DATA LIST

SPECIFICATION	TYPE, MODEL, SERIES	ITEM NOMENCLATURE
GOVERNMENT		SUU-25F/A	COVER, PROTECTIVE
CONTRACTOR			
CONTRACT NO.

ENGINEERING CHANGE ORDER / REQUEST

1. ECO NO: 86A155	ECO PAGE: 1 OF 1	2. DWG TITLE: COVER, PROTECTIVE, NOSE CONE, SDD-25 F/A		3. DWG FSCM NO: 98747	4. DWG NO: 8241331		
5. TYPE OF ECO	6. REASON(S) FOR CHANGE	7. NEXT ASSY: 8241332	8. USED ON: SDD-25 F/A	9. OPR FSCM NO: 98747	DWG SIZE: F	DWG SHEET(S) AFFECTED: 1	LATEST DWG REV LTR: A
ADVANCE	ERROR CORRECTION						
DEVIATION	DESIGN CHANGE						
CHANGE NOTICE	DRAWING CLARIFICATION	11. DOCUMENTS AFFECTED: TO # / TCTO # / ECC / OTHER: 8241332					
LIAISON	UPDATE DRAWING						
CHANGE REQUEST							
INFORMATION

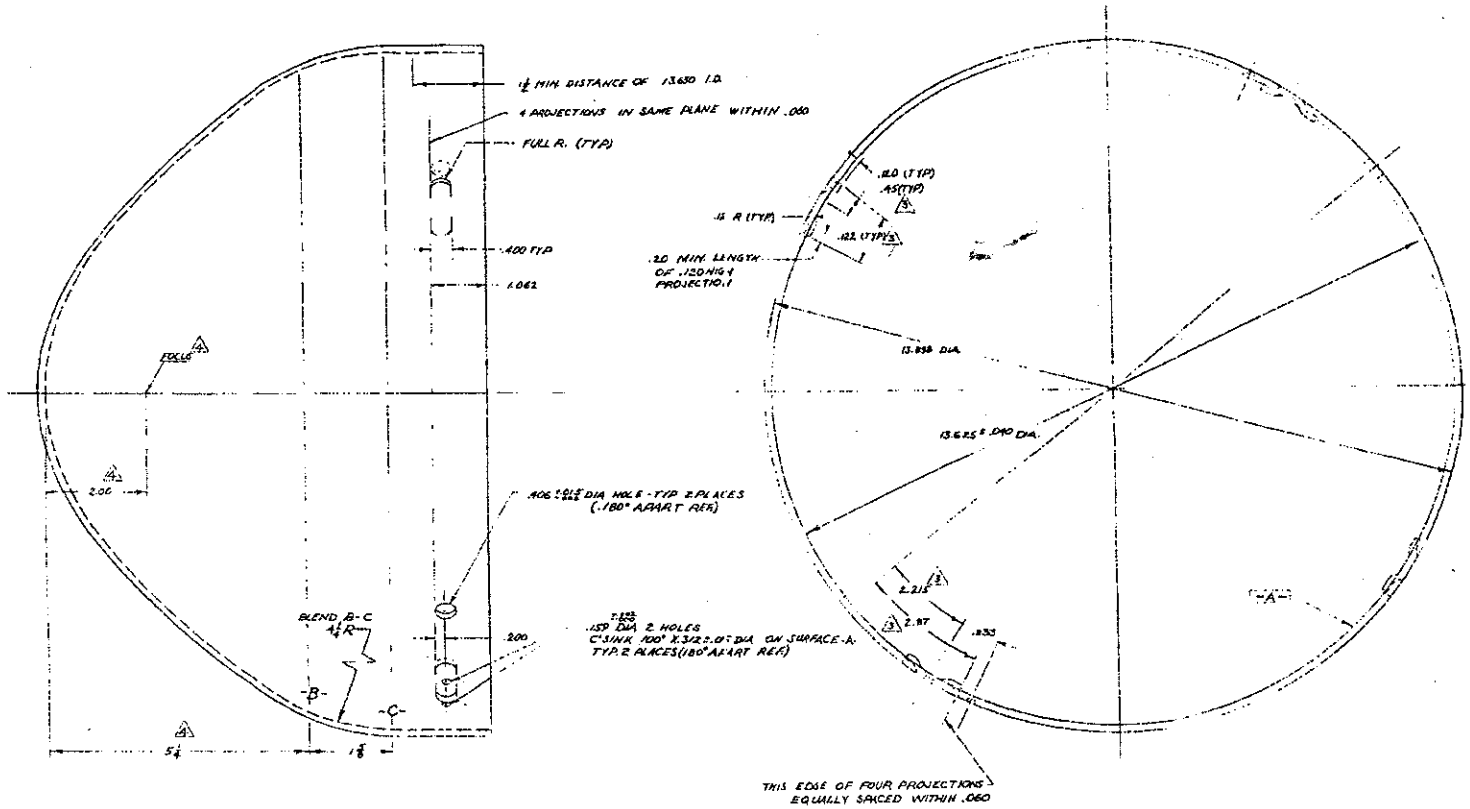
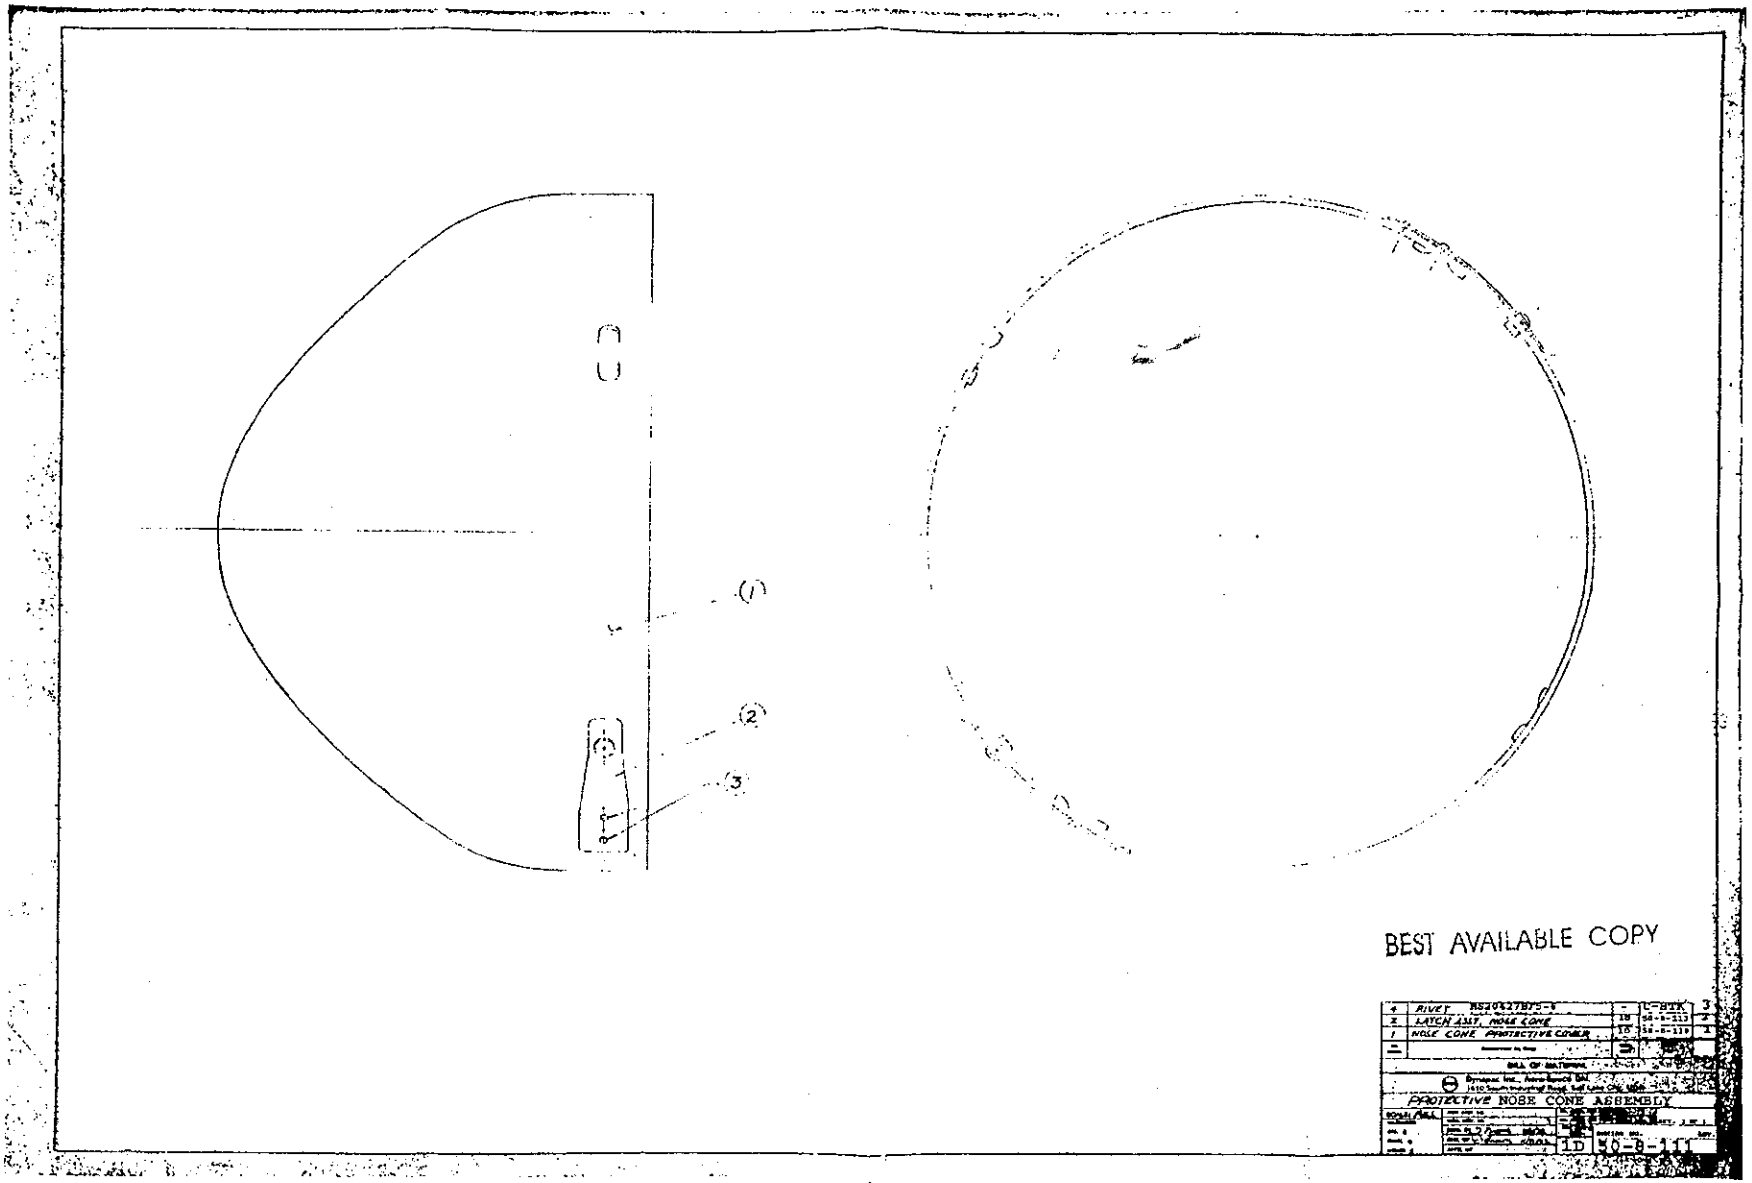
INCORPORATED AECO NO. 85A190 WITH CHANGES.

ZONE 6/G

WAS:

BLEND BETWEEN 'B AND C'
USING 4.5 R ....

ZONE 7/B

CHANGED DIMENSION:
WAS: 8.63 IS: 8.90

IS:

SEE DWG. FOR NOW CONDITION.
